# **BIENNIAL REPORT 111<sup>th</sup> CONGRESS**

## **AMERICANS WITH DISABILITIES ACT INSPECTIONS RELATING TO PUBLIC SERVICES AND ACCOMODATIONS**

**Office of Compliance  
August 2012**

# **Accessibility in the Legislative Branch – Report on Americans with Disabilities Act Inspections Relating to Public Services and Accommodations during the 111<sup>th</sup> Congress**

**Protruding Tree Branch Creating Barrier**

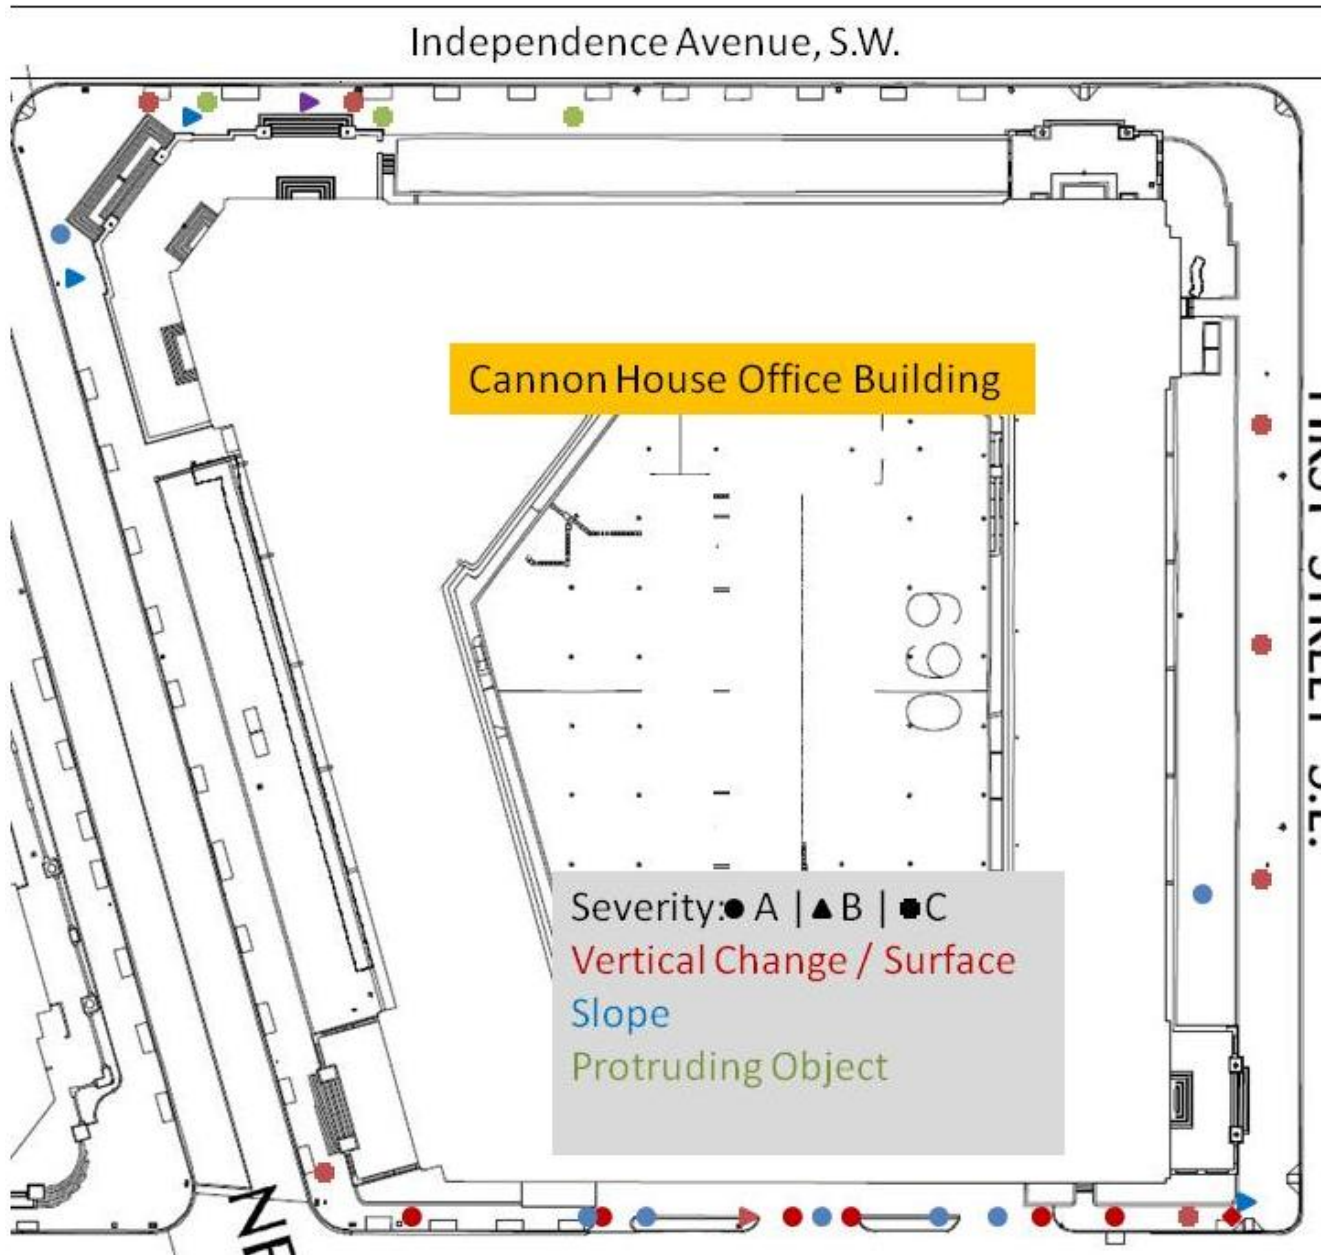
The OOC found 11 barriers relating to objects that protrude into the sidewalk corridors. Most of these are related to tree branches or plants that have grown into the corridor. Two of the 11 barriers are rated as “A” severities because, in one case (Barrier 88), the tree branch is thick enough to pose a cutting hazard, and in the other case (Barrier 129), the protruding ledge has a rough surface that could cause abrasions during contact. Of the remaining 9 barriers, 8 are rated as “C” severities while 1 is rated a “B” severity.

Location of ADA Barriers on Sidewalks Surrounding the Cannon House Office Building

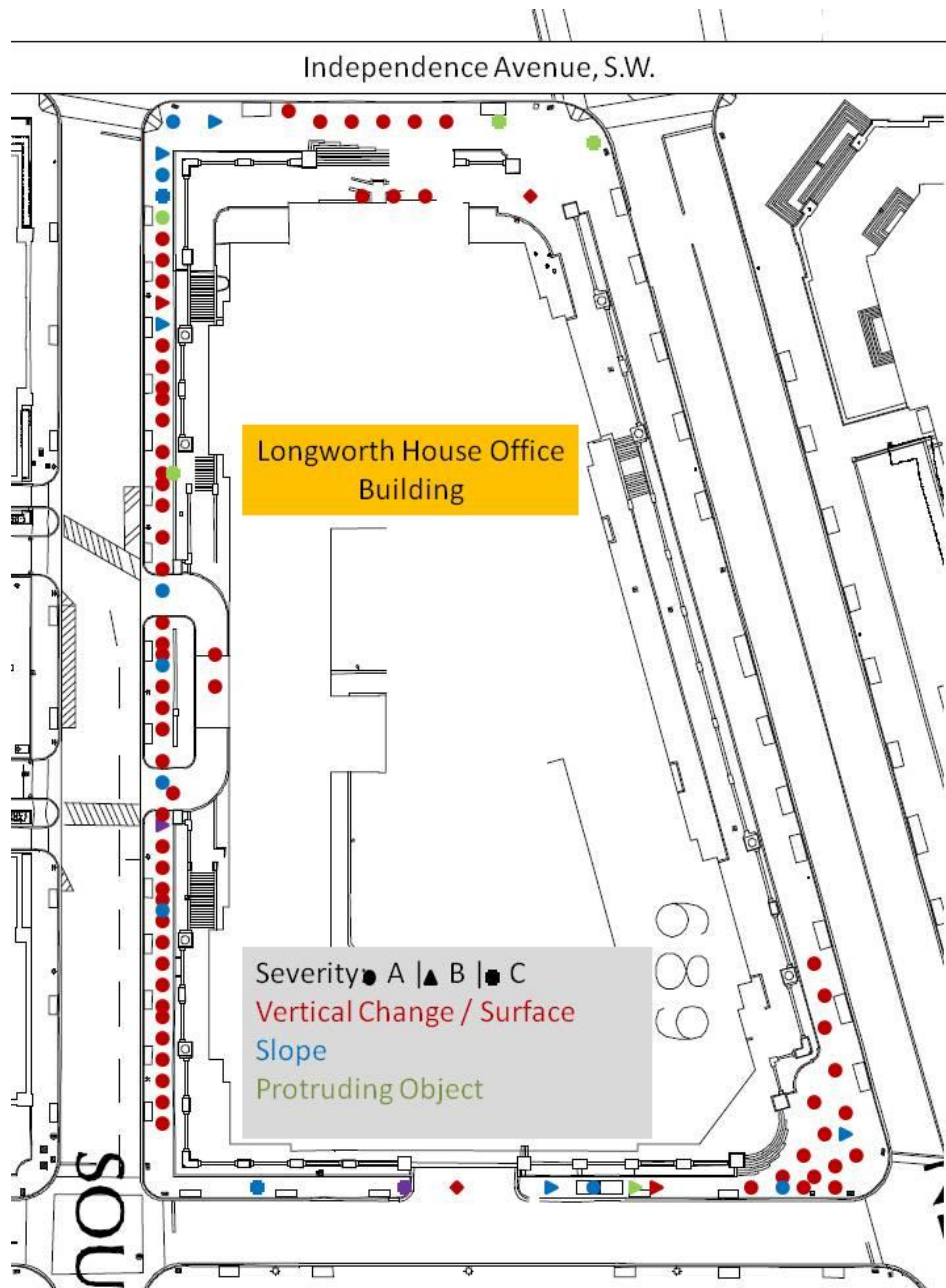
Barrier No	Existing Condition	Solution	SEV Code
13	SLAB JOINTS > 1/2" WIDE AND > 1/4" DEEP	Repair and/or fill sidewalk cracks and/or expansion joints.	C
16	CROSS SLOPE 4.4% TO 4.7%	Alter existing exterior route to reduce cross slope to 1:48 or less.	B
273	WHEELCHAIR SPACE SLOPES 6.1%	Alter floor as needed to provide a level area of at least the minimum required size at each wheelchair seating position.	A
5	VERTICAL TRANSITION > 1/2" HIGH	Repair and/or fill sidewalk cracks and/or expansion joints.	C
9	SLAB JOINT > 1/2" WIDE AND > 1/4" DEEP	Repair and/or fill sidewalk cracks and/or expansion joints.	C
22	CROSS SLOPE 3.8%	Alter existing exterior route to reduce cross slope to 1:48 or less.	B
25	TREE BRANCHES PROJECT > 4" AT 74" TO 79" ABOVE SIDEWALK	In the case of plants, trees, or shrubbery, trim planting to protrude no more than 4" or remove/relocate outside circulation path.	C
3	VERTICAL TRANSITION > 1" HIGH	Remove existing level transition and install compliant transition (1/4" Maximum height square or 1/2" Maximum height at 1:2 slope).	A

4	VERTICAL TRANSITION 1" HIGH	Remove existing level transition and install compliant transition (1/4" Maximum height square or 1/2" Maximum height at 1:2 slope).	A
6	JOINTS 1.5" WIDE AND 3/4" DEEP	Remove existing pavement and replace as necessary to eliminate noncompliant vertical offset.	A
8	CRACK 5" WIDE AND 1/2" DEEP	Repair and/or fill sidewalk cracks and/or expansion joints.	A
10	SLAB JOINT 1" WIDE AND 1/2" DEEP	Repair and/or fill sidewalk cracks and/or expansion joints.	A
11	CRACK > 1/2" WIDE AND > 1/4" DEEP	Repair and/or fill sidewalk cracks and/or expansion joints.	C
12	SLAB JOINT 1" WIDE AND 1/2" DEEP	Repair and/or fill sidewalk cracks and/or expansion joints.	A
14	MANHOLE COVER HAS GAPS 2" WIDE AND > 1/4" DEEP	Notify the owner of grating of noncompliance and request correction.	A
15	CLEAR WIDTH 29", OBSTRUCTED BY LIGHT POLE	Alteration requires complex redesign beyond the scope of this survey.	B

**Location of ADA Barriers on Sidewalks Surrounding the Longworth House Office Building**

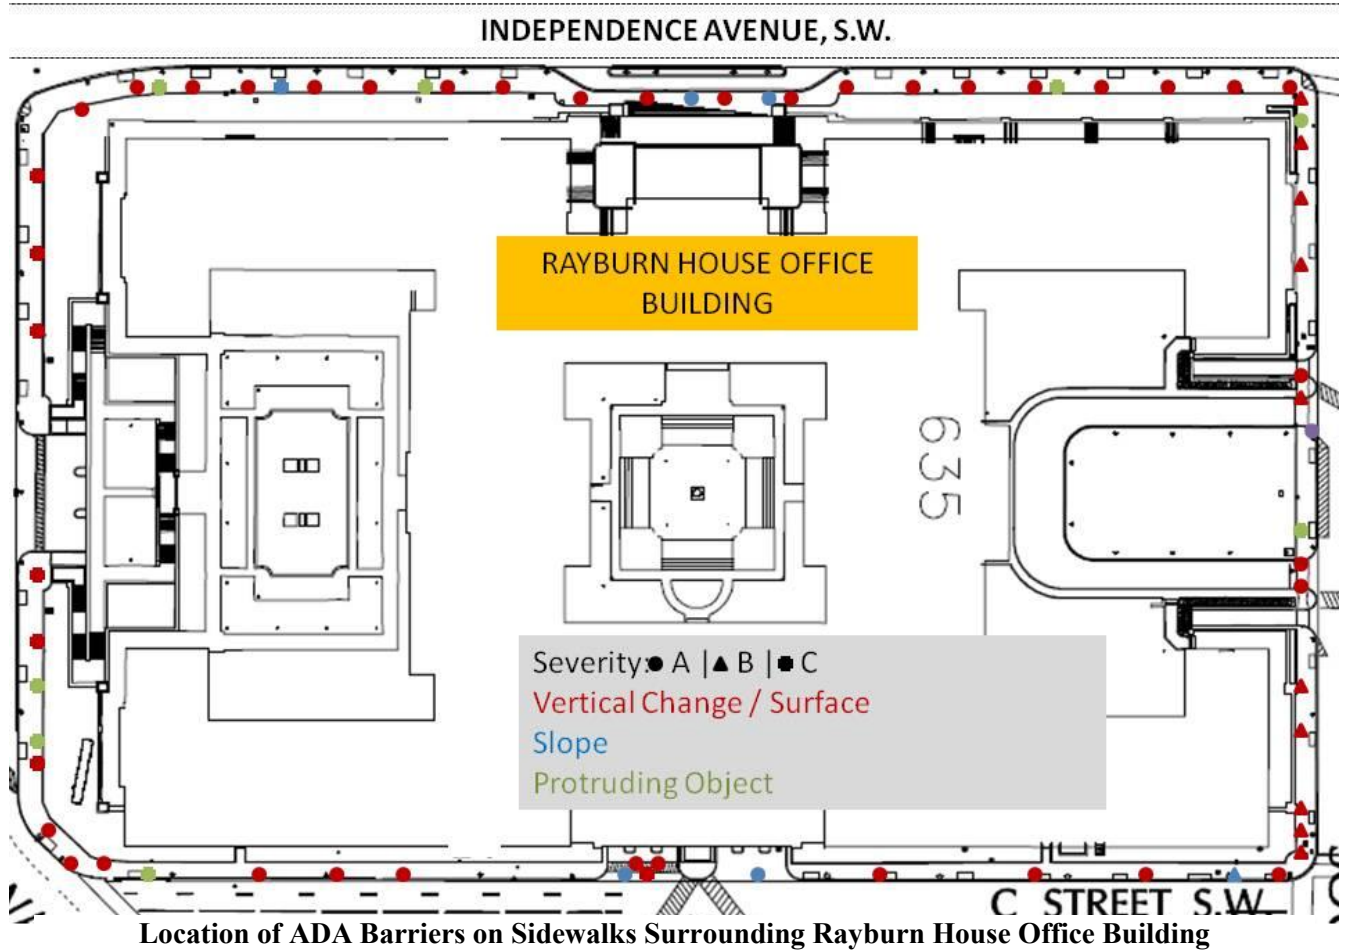
Barrier No	Existing Condition	Solution	SEV Code
195	3 ENTRANCE MATS LOOSE	Remove mat and install new compliant entrance mat or other compliant flooring. Install compliant edge transitions as needed.	A
196	CURB RAMP IS NOT PROVIDED WHERE ACCESSIBLE ROUTE CROSSES A CURB	Install a compliant curb ramp at this location.	B
58	SLAB JOINT >1/2" WIDE AND >1/4" DEEP	Repair and/or fill sidewalk cracks and/or expansion joints.	A
71	CROSS SLOPE 3.6-3.8%	Alter existing exterior route to reduce cross slope to 1:48 or less.	B
77	CROSS SLOPE 4.1-5.1%	Alter existing exterior route to reduce cross slope to 1:48 or less.	A
85	BOLLARD CHAINS PROJECT 12" AT 27.5" ABOVE SIDEWALK	Lower existing item into the range of cane detection. Repair/refinish as needed. Comply with reach ranges, clear floor space, etc.	C
87	TREE BRANCH PROJECTS AT 74" ABOVE SIDEWALK	In the case of plants, trees, or shrubbery, trim planting to protrude no more than 4" or remove/relocate outside circulation path.	C

90	WHEELCHAIR SPACE SLOPES 8.0%	Alter floor as needed to provide a level area of at least the minimum required size at each wheelchair seating position.	A
63	SLAB JOINT 3/4" WIDE AND >1/4" DEEP	Repair and/or fill sidewalk cracks and/or expansion joints.	B
67	SLAB JOINTS 3/4" WIDE AND 1/2" DEEP	Repair and/or fill sidewalk cracks and/or expansion joints.	A
70	CROSS SLOPE 3.5-5.5%	Alter existing exterior route to reduce cross slope to 1:48 or less.	A
72	CROSS SLOPE 3.5%	Alter existing exterior route to reduce cross slope to 1:48 or less.	C
73	CROSS SLOPE 3.7%	Alter existing exterior route to reduce cross slope to 1:48 or less.	B
84	CROSS SLOPE 4.7%	Alteration requires complex redesign beyond the scope of this survey.	A
86	TREE BRANCHES PROJECT AT 72" TO 74" ABOVE SIDEWALK	In the case of plants, trees, or shrubbery, trim planting to protrude no more than 4" or remove/relocate outside circulation path.	B

52	VERTICAL TRANSITION 3/4" HIGH	Remove existing level transition and install compliant transition (1/4" Maximum height square or 1/2" Maximum height at 1:2 slope).	A
53	VERTICAL TRANSITION 1/2" HIGH AND IS NOT BEVELED 1:2	Grind existing surface at change in level to 1:2 slope or less.	B
55	ENTRANCE MAT LOOSE	Remove mat and install new compliant entrance mat or other compliant flooring. Install compliant edge transitions as needed.	A
56	GRATINGS 1" WIDE	Remove existing noncompliant grating and install new compliant grating.	A
57	SLAB JOINT >1/2" WIDE AND >1/4" DEEP	Repair and/or fill sidewalk cracks and/or expansion joints.	A
61	SLAB JOINTS >1/2" WIDE AND >1/4" DEEP	Repair and/or fill sidewalk cracks and/or expansion joints.	A
62	CRACK 3/4" AND 1/2" DEEP	Repair and/or fill sidewalk cracks and/or expansion joints.	A
66	CRACK 2" WIDE AND 1" DEEP	Repair and/or fill sidewalk cracks and/or expansion joints.	A
